National Electrical Safety Code
Interpretations
1988—1990 inclusive

National Electrical Safety Code Committee, ANSI C2

Abstract: This edition includes official interpretations of the National Electrical Safety Code as made by the Interpretations Subcommittee of the National Electrical Safety Code Committee, ANSI C2.

Fig IR 426-1

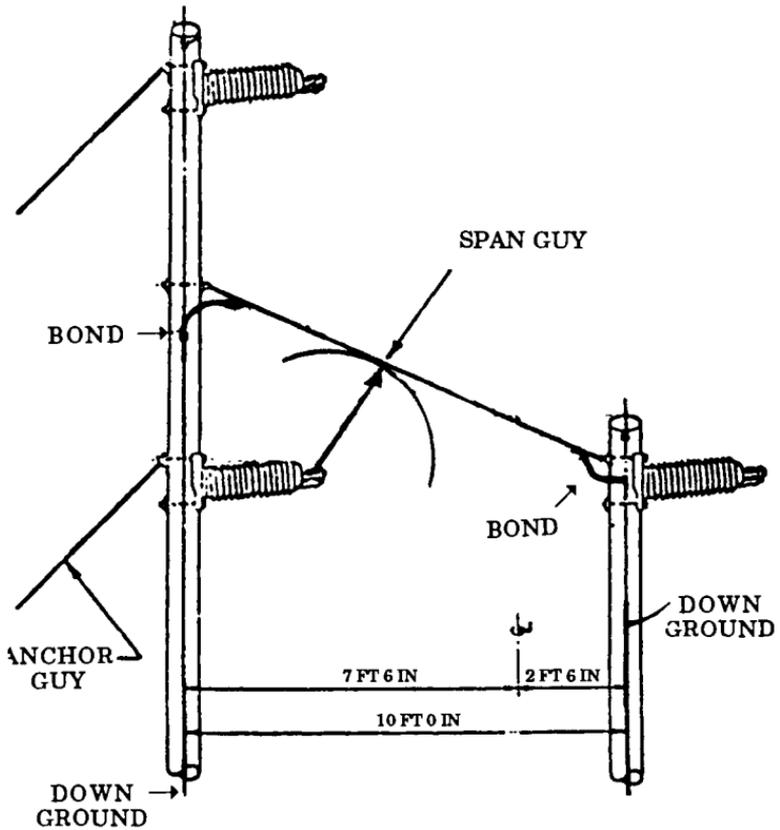
Please furnish an interpretation of Rule 235E of the 1987 Edition of the National Electric Safety Code:

The span guy, as shown in Fig IR 426-1, is considered as "all other guys" and the required clearance from the phase to the span guy, for a system operating at 69 kV, Table 235-6, would be 31.98 in [23 in + (69(1.05) - 50)0.4]. If that same span guy were bonded to the down grounds of both poles to which it was attached, can the required clearance from the phase to the span guy be considered as if it were an "anchor guy" and the clearance reduced to 21.61 in [16 in + (69(1.05) - 50)0.25]?
